DEPARTMENT OF THE AIR FORCE
377TH AIR BASE WING (AFGSC)

July 19, 2018

Subject: Phase 3 Ethylene Dibromide In Situ Biodegradation Pilot Test Notification Letter, Bulk Fuels Facility, Kirtland Air Force Base, New Mexico

Figure 1. EDB Concentrations (Note: 106IN1 concentrations during recirculation phases are calculated from the flow-weighted average of the concentrations from 106EX1 and 106EX2)

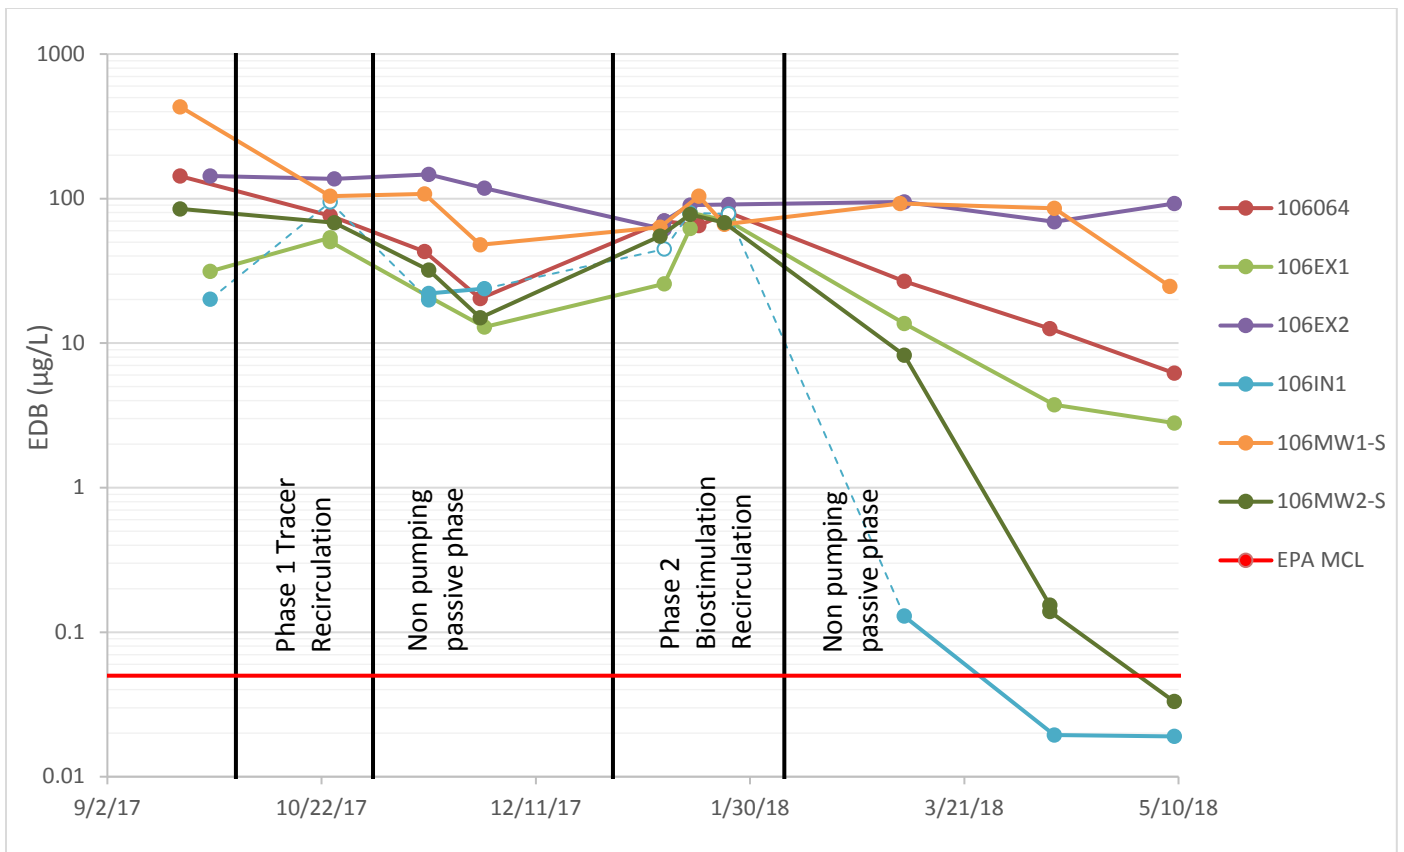
Concentrations of EDB have decreased significantly at two shallow groundwater monitoring (GWM) wells (KAFB-106MW2-S and KAFB-106064) and are no longer detectable at the injection well (KAFB-106IN1). EDB concentrations at KAFB-106MW2-S have decreased three orders of magnitude, from 77.7 to 0.033 (J-qualified) micrograms per liter ($\mu\text{g/L}$), since the period of active recirculation in Phase 2. This GWM well is located closest to the injection well at approximately 25 feet to the southwest. EDB concentrations in KAFB-106064 have decreased by one order of magnitude, from a maximum of 80.3 $\mu\text{g/L}$ during active recirculation to 6.2 $\mu\text{g/L}$ during the recent passive sampling event in May 2018.

The remaining shallow GWM well (KAFB-106MW1-S) and extraction well KAFB-106EX1 have also exhibited notable decreases in EDB concentrations, while relatively stable EDB concentrations have

been observed at the second extraction well (KAFB-106EX2). Concentration trends of EDB throughout the pilot test are presented in Figure 1.

Due to the initial success of biostimulation, a second biostimulation phase will be performed rather than bioaugmentation as originally proposed in the Work Plan (USACE, 2016). Based upon the current field results, which indicate that native dehalogenating bacteria are effectively degrading EDB in the subsurface, bioaugmenting with an exogenous dehalogenating culture (SDC-9) does not appear necessary at this time.

This additional biostimulation phase (Phase 3) will be conducted similarly to Phase 2, which consisted of a recirculation phase in which sodium lactate and diammonium phosphate were injected into groundwater, and a subsequent passive monitoring period. Active recirculation is anticipated to take approximately 1 month. After active recirculation, groundwater will be monitored for approximately 3 to 4 months. The sample regimen for Phase 3 will be in accordance with the NMED-approved EDB In Situ Biodegradation Pilot Test Work Plan (USACE, 2016).
